From: Dan Kellow <Dan.Kellow@huttcity.govt.nz>
Sent: Wednesday, 23 October 2019 1:07 PM
To: Shannon Watson <Shannon.Watson@ghd.com>
Subject: FW: Eastern Bays Shared Path LVA addendum to include assessment of project with safety barriers

FROM: David Wanty, Wanty Transportation Consultancy; CPEng, M.ITE

RM190124: Eastern Bays shared path (also RM WGN190301 re GRWC).

ISSUE DATE: 9/05/2019 REVISED: 19/8; 23/9; 25/10/19 SITE VISITS: 2/5/19

Figure 3-11: Coastal Edge Treatment

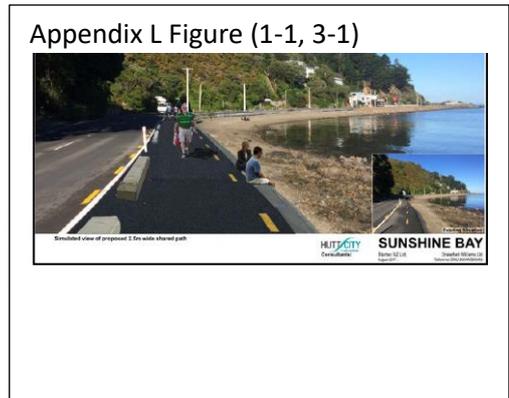
No seaward side barrier is currently proposed⁵.

However the proposed “concrete coastal edge treatment” does not include any vertical element, preventing an errant skateboard or e-scooter for example (or their user) from going into the sea.

The height of the kerb separators was not dimensionalised but is understood to be 150 mm. As this is corresponds to the pedal clearance of my 26” mountain bike they should preferably be lower since if inadvertently struck a rider could potentially be thrown out of alignment or even over the edge.

Figure 4-1: Eastern Bays (Point Howard) - Observed Cyclists Volumes 2017 (tube count survey)

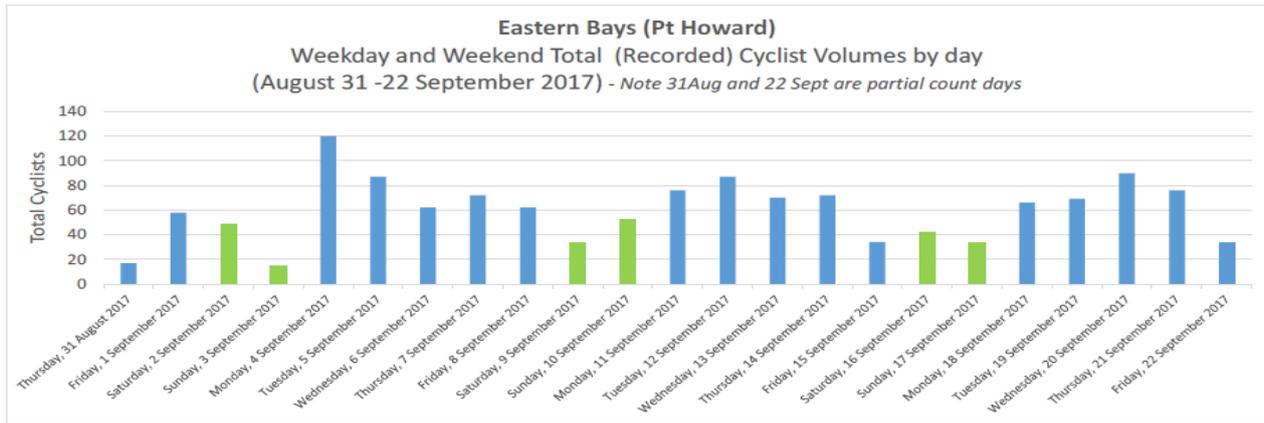
These daily flows when converted to peak hour flows would seem to suggest from Figure 4 that a shared path width of 2.5 m is sufficient (in a favourable situation) from a convenience viewpoint.
